Our ref 1000026450
Your ref 2017/4551/P
Direct line 0207 852 4742
jeff.field@eu.jll.com

11-12 Grenville Street, London, WC1N 1LZ – Planning Application 2017/4551/P

Figure 2: Horns on a window on the building's front elevation (Source: Google Streetview)

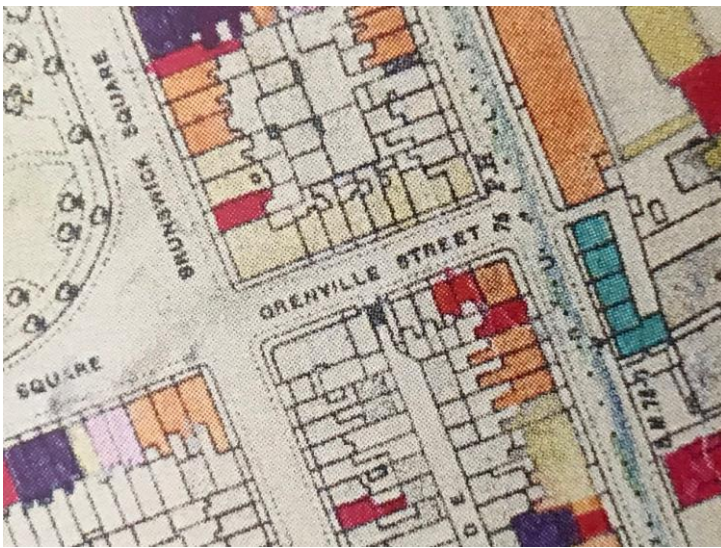
The comments consider that horns on the sashes of the front elevation's windows are not visible and that this suggests that they date from before about 1850. CAAC also asks that the windows are preserved if they are original.

"Further to our conversation earlier, please find attached an extract from the relevant LCC Bomb Damage map. The darker colours represent the greater damage - black indicates 'total destruction'.

This seems to indicate that the part of the site directly above the arch was destroyed. Looking at the front elevation, I don't think this was the case, but the rear elevation could indeed be a rebuild. I would point out that, while I haven't been to the site recently, the Google Street View image of the front elevation (date of image capture September 2017, attached) clearly shows windows with horns. The same windows occur on the rear elevation. The same windows appear in our site visit photos from 2009... In any event, it appears likely that the windows, at the very earliest, date from the post-war period."

Reviewing KMHeritage's response, we consider it unlikely that the windows are original and that it is therefore appropriate for the windows to be replaced as proposed.
